GEOTECHNICAL DESIGN REPORT

Avila Beach Drive at US 101 Interchange Improvements

May 17, 2023

**Subject: Geotechnical Design Report, Avila Beach Drive at US 101 Interchange
Improvements, 05-SLO-101- PM 20.9 – 21.3, 05-1G4800 - 0515000038, San Luis
Obispo County, California**

Figure 2: Geologic Map (Wiegers and Gutierrez 2011)

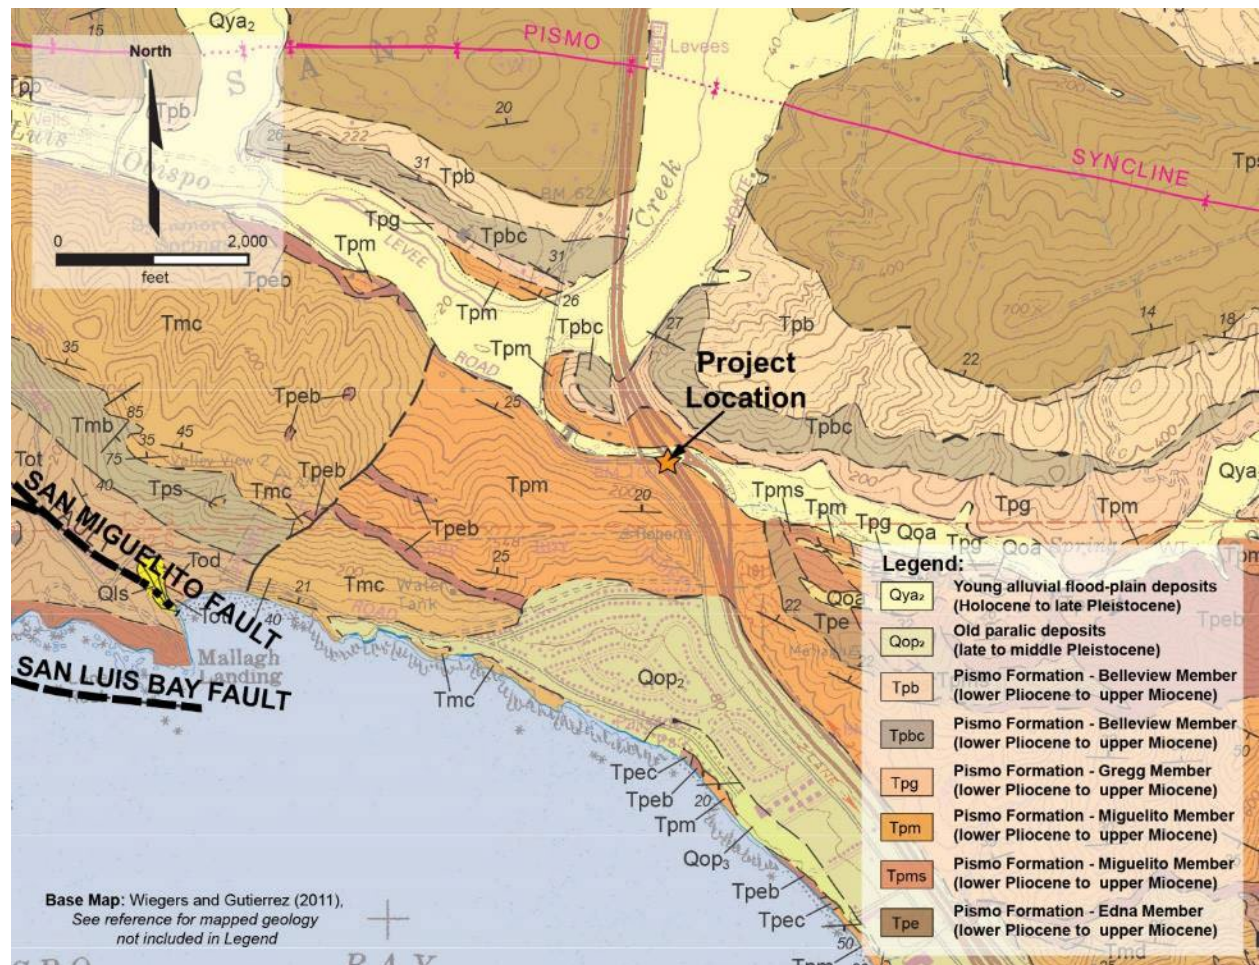
P-2	FR/Section 2.1		Please provide the vertical datum reference for the "elevation 97 feet".	Yeh will provide datum to NAVD88 – <i>Completed 9-23-22</i>
P-2	FR/Section 2.2		<ol style="list-style-type: none"> Figure 2 indicates WG 2021b and 2021c; however, 3rd line indicates WG 2021a and 	<ol style="list-style-type: none"> No change needed

Figure 3: Caltrans ARS Curve

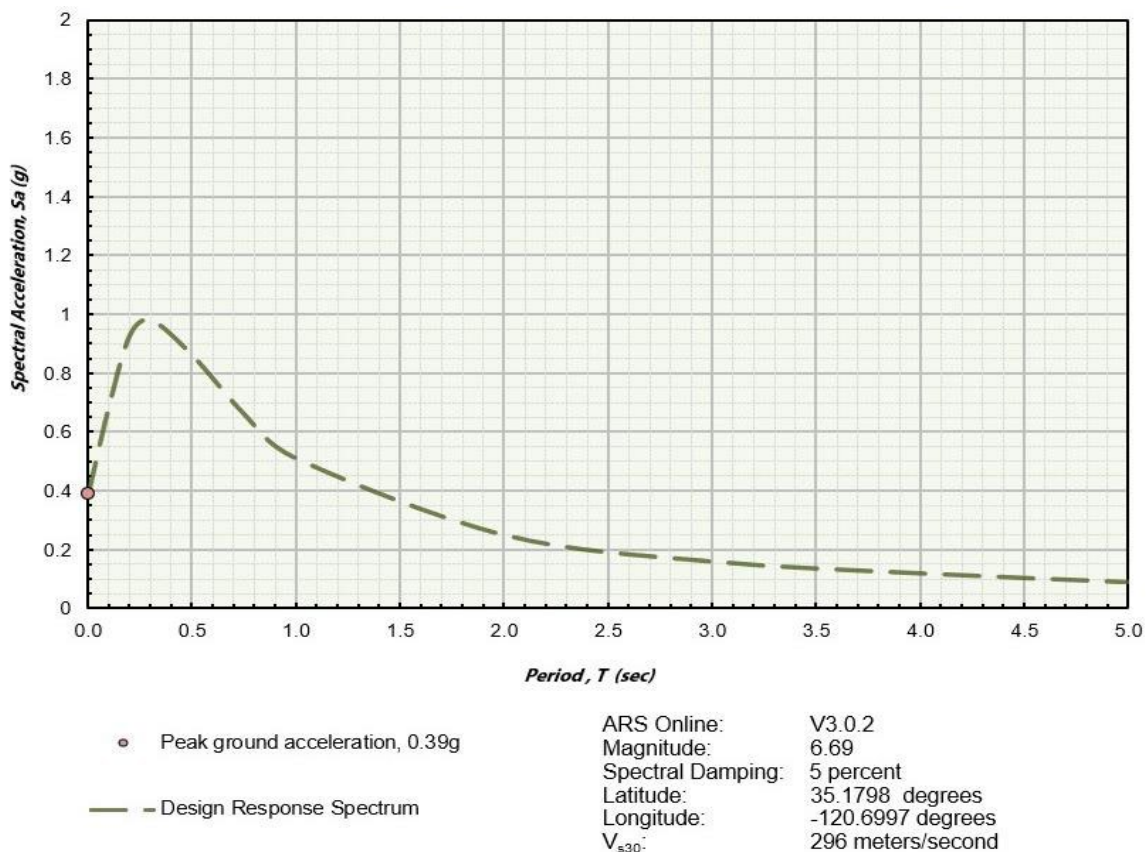
#	Doc. (See Note 1)	Page, Section, or SSP	Review Comments	Consultant Responses	✓
5	FR	Page 13	ARS curve is not required for retaining wall design. Recommend removing the Figure 5.	Comment noted. The ARS curve is provided as a basis for the seismic design. It is provided as additional pertinent design information.	
6	FR	Page 17	<p>Table 6,</p> <p>Geotech is not recommending the ground anchor vertical and horizontal spacing, and foundation soil factored nominal bearing resistance for facing.</p> <p>Instead, need to provide the apparent earth pressures (AEP) for wall (active, and passive). Please estimate the AEP or since soil properties are provided, let structure estimate them.</p> <p>e.g. <i>“To determine lateral pressures for the soldier pile wall, Figure 3.11.5.7-1 (b) of section 3.11.5.7 – Apparent Earth Pressures (AEP) for Anchored Walls (active and passive) from AASHTO LRFD Bridge Design Specifications, Eighth Edition, shall be used.”</i></p>	<p>Tables for Ground Anchor and Soil Nail Walls do include columns with recommendations for “maximum Ground Anchor Vertical Spacing”, “Maximum Ground Anchor Horizontal Spacing”, and “Foundation Soil Factored Nominal Bearing Resistance for Facing”. Updated values will be provided in the final version of the FR.</p> <p>Geotechnical design properties were provided in the Foundation Report for the structure designer for use with estimating the AEP. Yeh will clarify the AASHTO LRFD Bridge Design AEP figure 3.11.5.7-1(b) should be used in the design.</p>

<p>Please attach ARS online output in an Appendix. Mean magnitude and site to source distance is not matching. Please check.</p> <ul style="list-style-type: none"> Please add a sentence of kh value. 	<p>4. Plot on Figure 3 of report is a direct output of ARS online data. Including output data is redundant. Mean magnitude and site to source distance match our output data from ARS online</p> <p>5. Kh value not applicable to the improvements in this report. Design kh and associated discussions for each wall are provided in Section 11.3 of the Foundation Report</p>
P-15	GDR/Section 4.6.2		Please also include not within 1,000 feet of an unzoned fault that is Holocene or younger in age.	Yeh will revise. – Completed 9-28-22
P-15	GDR/Section 4.6.3		<ol style="list-style-type: none"> Please indicate that the calculation is attached is Appendix and include the calculation in an appendix. Please do not use "considered to be low". As per liquefaction module, use the liquefaction potential does not exist. 	<ol style="list-style-type: none"> Calculations provided in Appendix D Comment noted. With respect, we will leave this statement as-is. Use of absolute or certainty such as "liquefaction potential does not exist" is against Yeh internal risk management policy.
